Final Report - Corrections Required **Application No. DEPN-24-0160**

Description : Multi-family development with 170 rental duplex units on one development lot. Also a request for alternate landscape compliance related to placement of streamside overly and property boundary buffer plantings, and to be allowed to provide 9.4% active open space where 10% is required.

Document Filename : Cottages at Kettle Creek DP_1st_Submittal_101524.pdf

COTTAGES AT KETTLE CREEK

STREAMSIDE OVERLAY PLAN

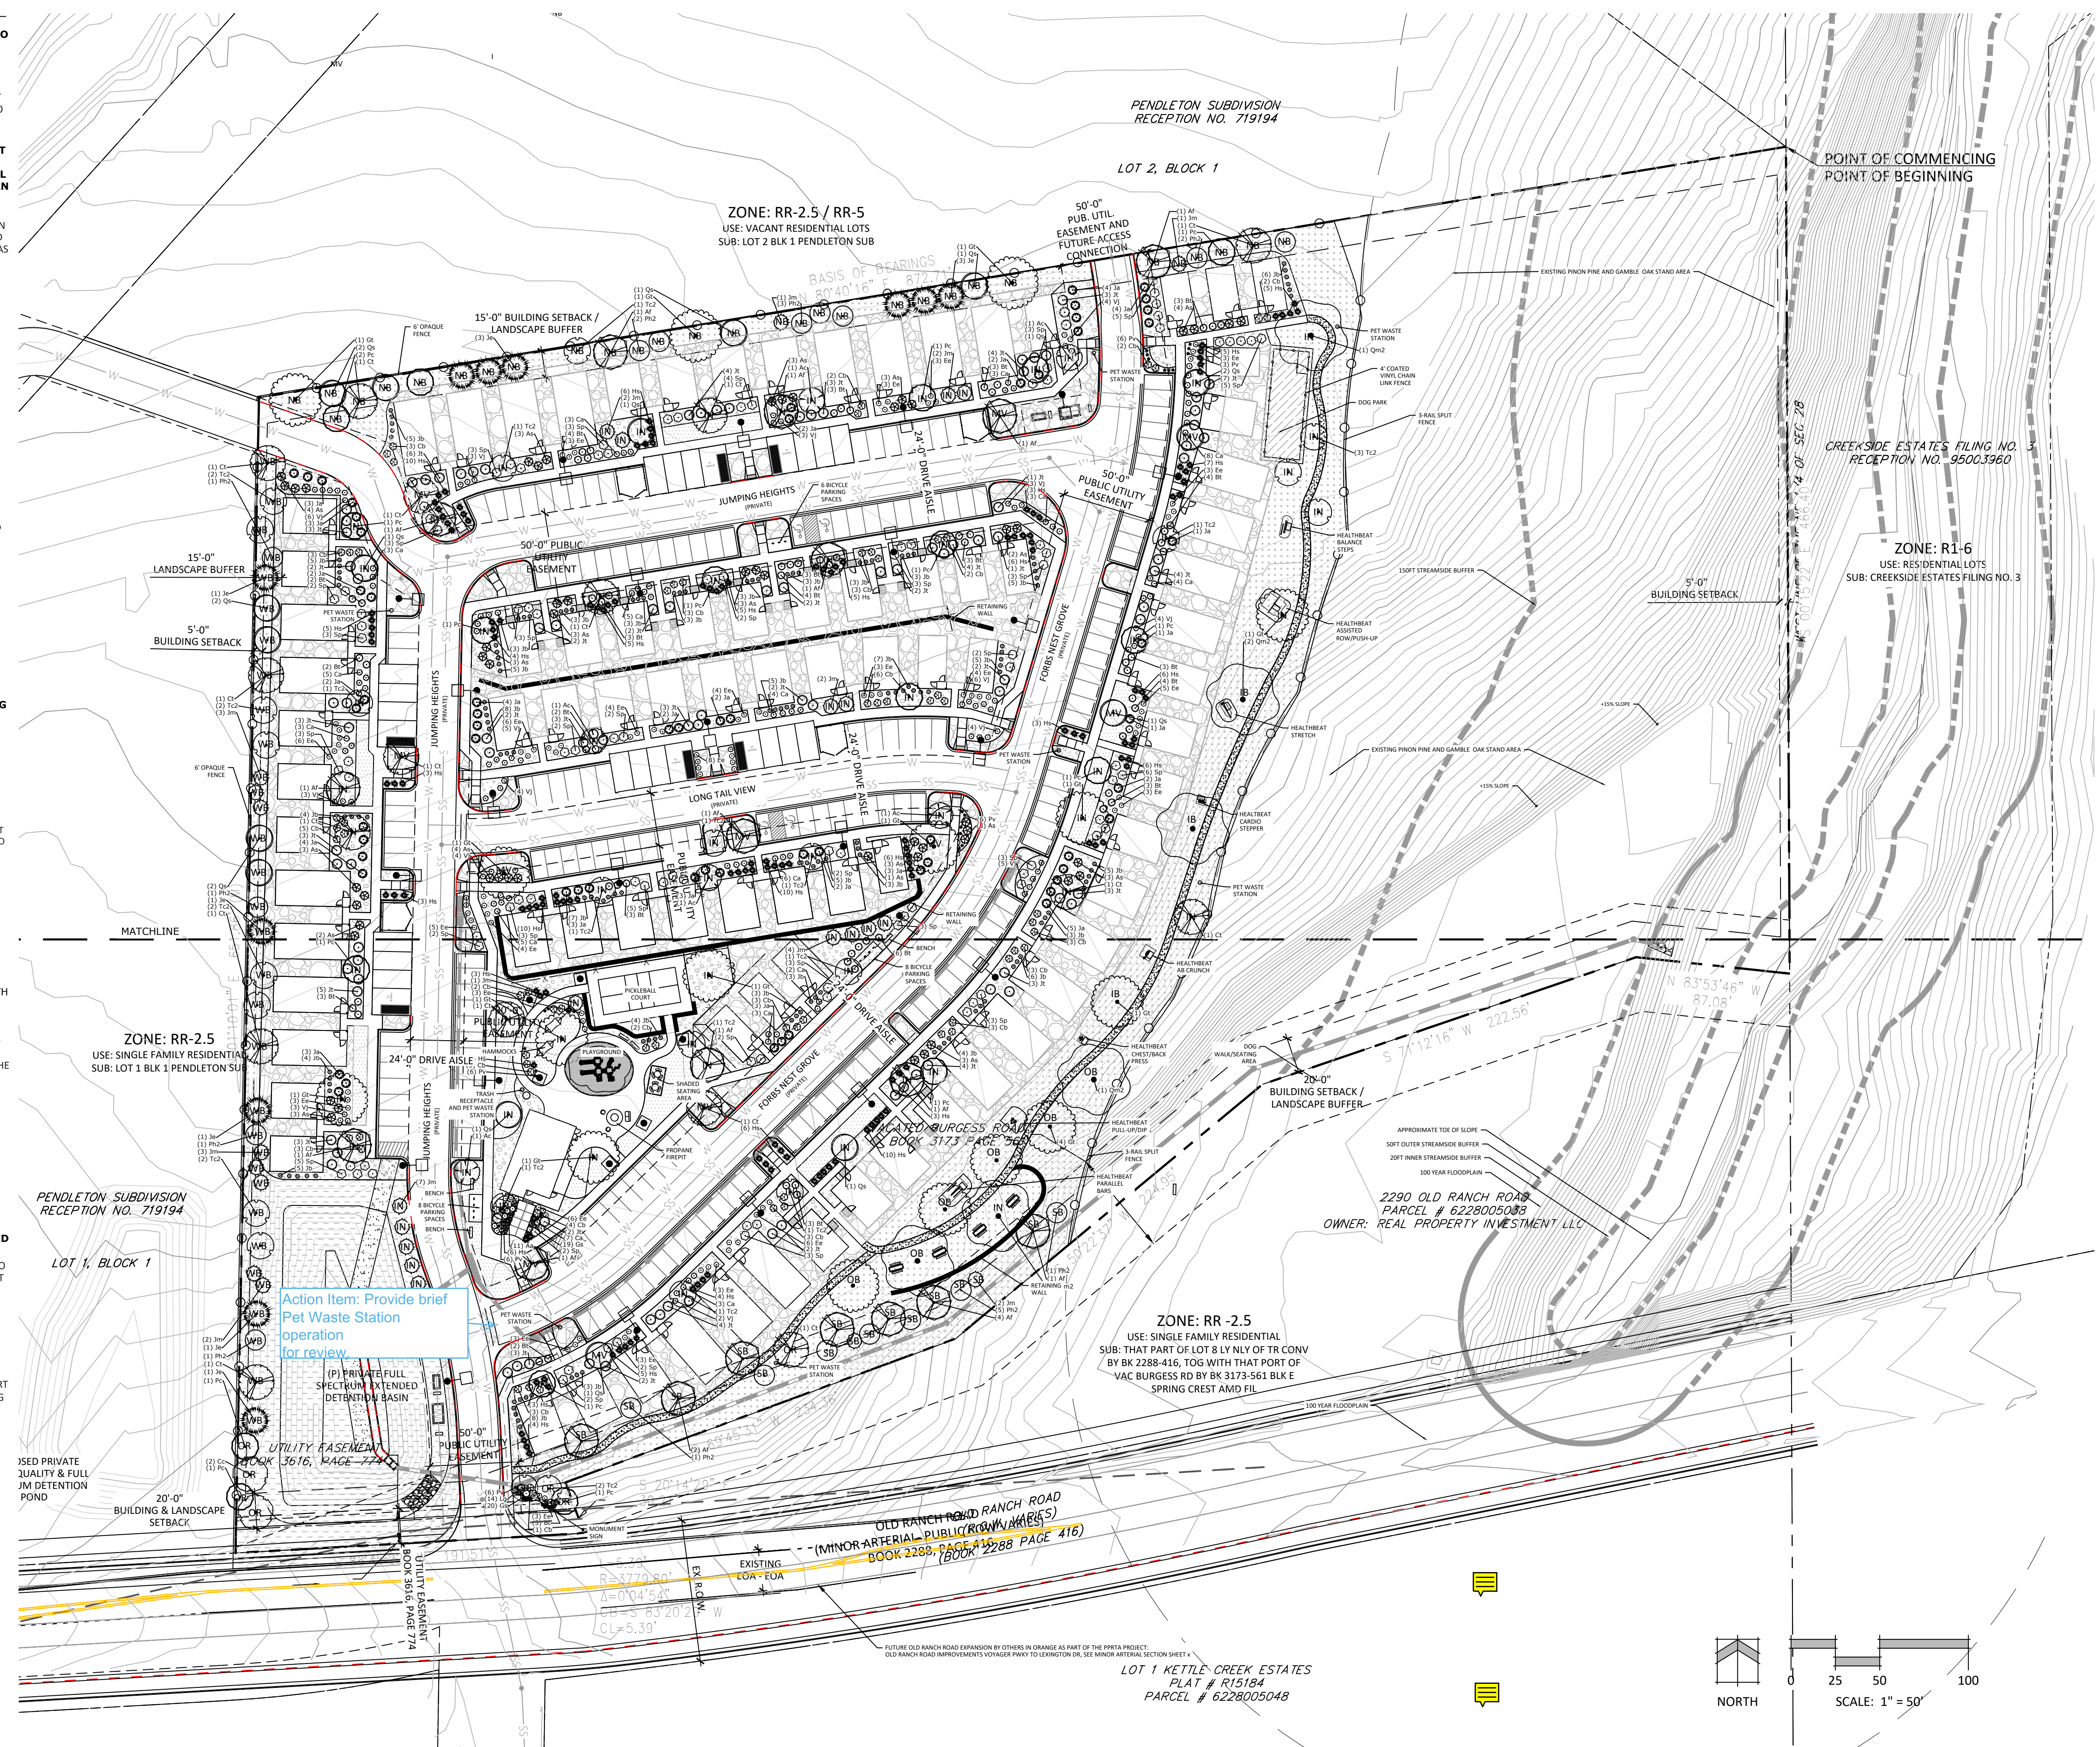
Action Item: Provide brief Pet Waste Station operation for review
